Solution for EMI

Model name : WTN-17WE2

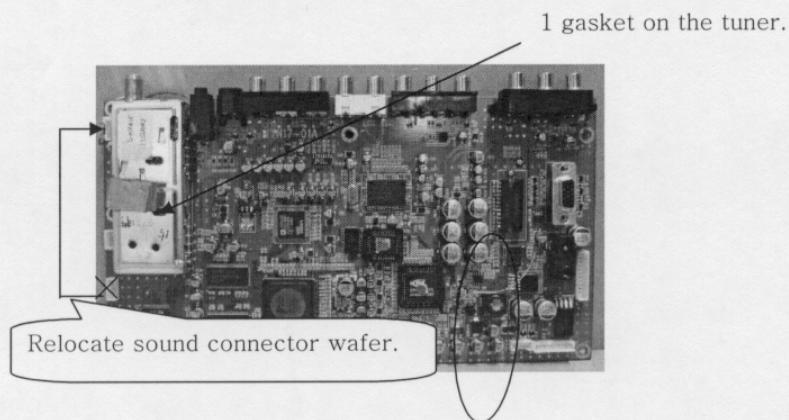
1. Attachment a gasket on the LCD module. (see the picture below)

2. Attachment a gasket on the tuner. (see the picture below)

3. Relocate the connector wafer which outputs TV sound and its additional works.

The wires will be modified with PCB pattern artwork.
